**STATE OF CONNECTICUT  
CONNECTICUT SITING COUNCIL**

<b>PETITION NO. 1597 – Greenskies Clean Energy LLC petition for a declaratory ruling, pursuant to Connecticut General Statutes §4-176 and §16-50k, for the proposed construction, maintenance and operation of a 3.74-megawatt AC solar photovoltaic electric generating facility located at Parcel No. 017-150-066, Spencer Hill Road, Winchester, Connecticut, and associated electrical interconnection. Council Interrogatories to Petitioner.</b>	<b>Petition No. 1597</b>
	<b>January 8, 2024</b>

Petitioner Greenskies Clean Energy LLC (“Petitioner” or “GCE”) hereby submits the following responses to the Interrogatories that were directed to GCE by the Connecticut Siting Council (“Council”) on December 18, 2023.

**Photo 1**  
**Site Access Road and Neighboring Residence**

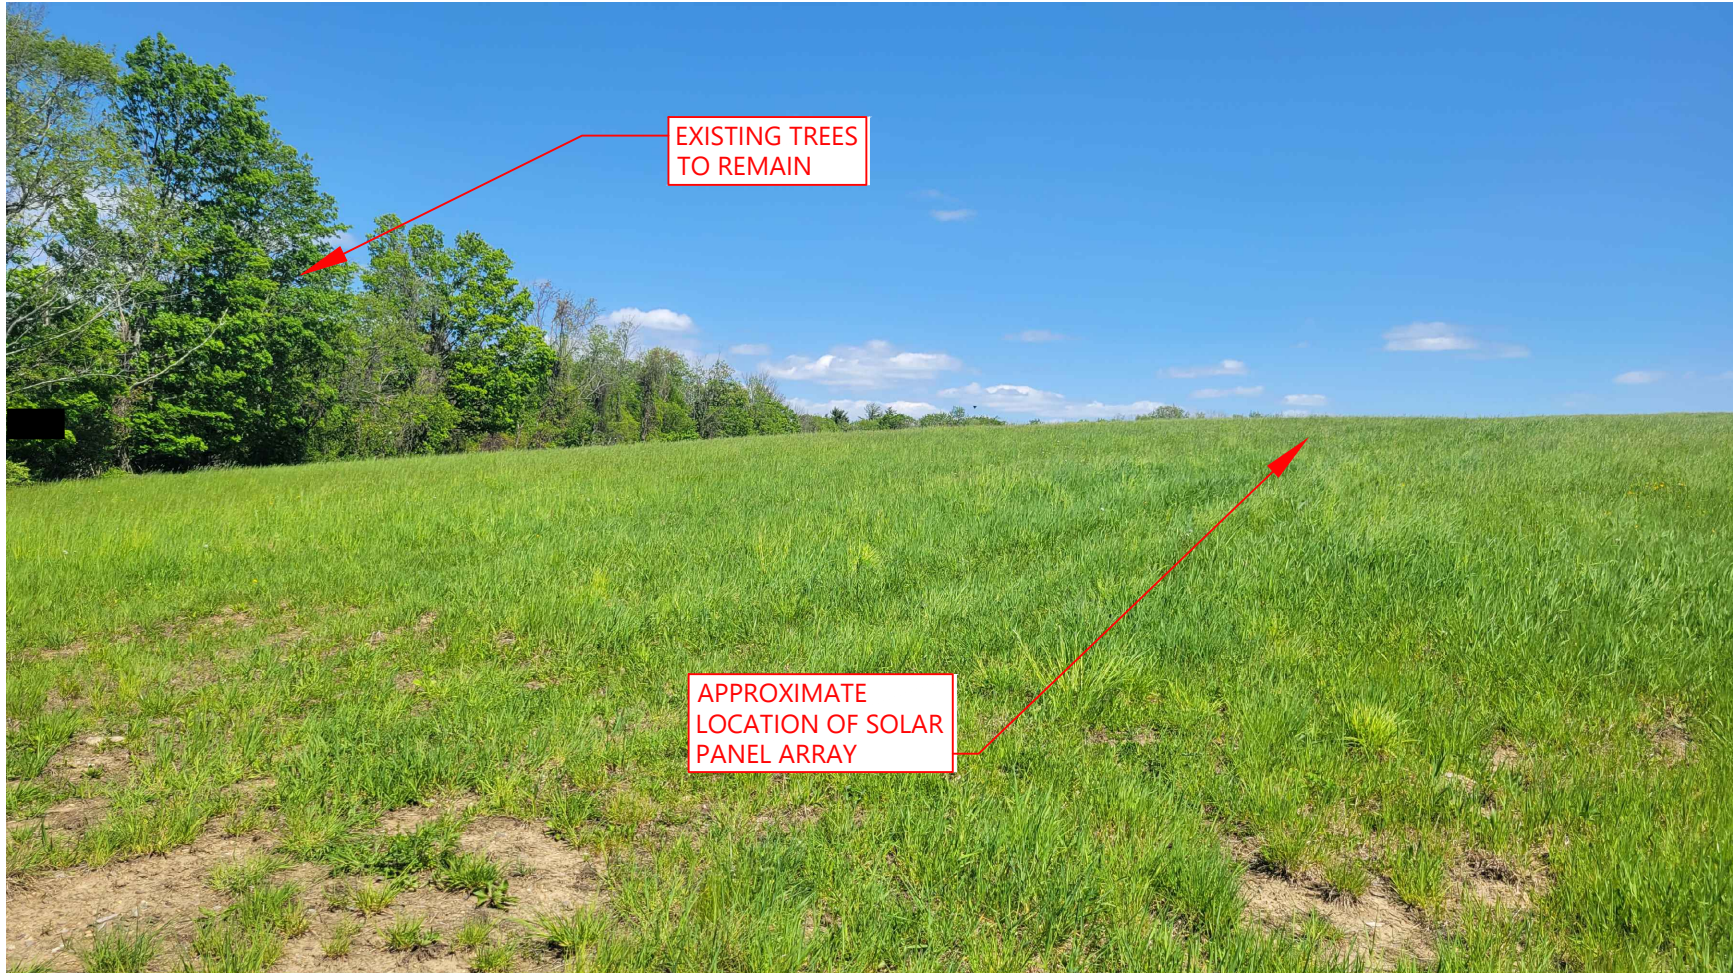
47. Submit photographic site documentation with notations linked to the site plans or a detailed aerial image that identify locations of site-specific and representative site features. The submission should include photographs of the site from public road(s) or publicly accessible area(s) as well as Site-specific locations depicting site features including, but not necessarily limited to, the following locations as applicable:

49. DEEP’s General Permit Appendix I states 50-foot wetland buffers shall be comprised of existing dense herbaceous vegetative ground cover. Provide information regarding the presence of this ground cover type within the proposed wetland buffer areas.

A photo log exhibit has been prepared and is included herewith as Exhibit B.

The existing hay field grows well when it is not continually harvested with vegetative growth removed. Refer to photos included as part of Interrogatory Number 47. Prior to construction and in line with the proposed construction sequence, it is intended to allow the site to fully vegetate. This will drastically reduce the risk of sedimentation to any off-site areas or onsite wetland resources. No work is proposed within 50 feet of any wetland on the Project.
